UNITED STATES PATENT AND TRADEMARK OFFICE

10/080,836

Charles M. Heldebrant

Office Action Summary

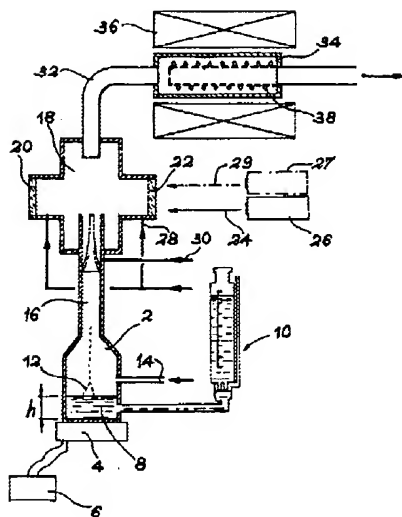
2. Claims 37, 38, 42-44, and 64 are rejected under 35 U.S.C. 102(b) as being anticipated by Cauchetier et al (FR 2677558).

Cauchetier et al teaches a method of treating a material wherein a liquid solution of

material 8 is separated into droplets 12 which are then passed through an exposure region 18 and exposed to a source of energetic emission 27,28. A source of inert gas (Argon) is injected at several locations 28,30 within the exposure region and is disclosed by Carchetier et al to surround the droplets axially, thus urging them away from the walls of the exposure region. Drying chamber 34 collects the treated particles.

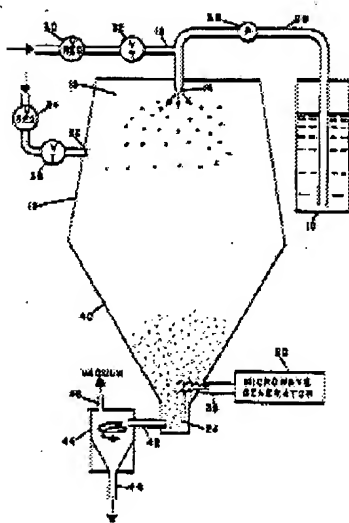
4. Claims 37, 38, 41-47, 49, 50, 64, 67, and 69-71 are rejected under 35 U.S.C. 103(a) as being unpatentable over Haugh (U.S. Patent No. 4,549,053) in view of Shaw et al (U.S. Patent No. 5,209,821).

With respect to claims 37, 38, 42, 64, 67, and 69-71, Haugh teaches a method of treating

a material wherein nozzle 14 creates droplets that are passed through an exposure region 40 where they are subjected to an energetic emission from source 20. The rate at which the droplets are created is controlled (col.4, lines 21-23). A collection chamber 24 collects the treated droplets and a gas filter (vacuum) removes gas from the flow. A product that may be treated by the method of Haugh includes pharmaceuticals and protein-containing materials. Haugh does not disclose a gas nozzle arranged within the exposure region designed to produce a

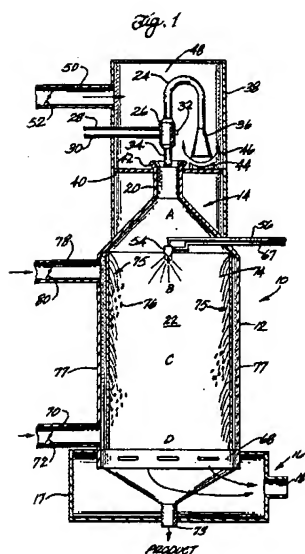
flow of gas along the walls of the exposure region such that droplets are urged away from the walls of the exposure region by the gas flow.

Shaw et al teaches a similar method of treating material, wherein the energetic heat source (microwave generator) is substituted with a source of hot air. In addition, Shaw et al discloses the use of at least one gas nozzle 70,78 which are arranged to produce an air curtain within region 22, thereby preventing droplets from contacting the walls of the region. Shaw et al discloses that the turbulence created

within the chamber tends to create eddies, urging the product to impinge the wall, affecting product quality. Since Haugh discloses that drying gas is introduced through port **22** will cause a swirling motion in the chamber (col.4, lines 4-11), it would have been expected that wall impingement would have been a problem, and the corresponding affect on product quality also a problem. Thus, it would have been obvious to modify the apparatus of Haugh using the teachings of Shaw et al to include an air curtain.
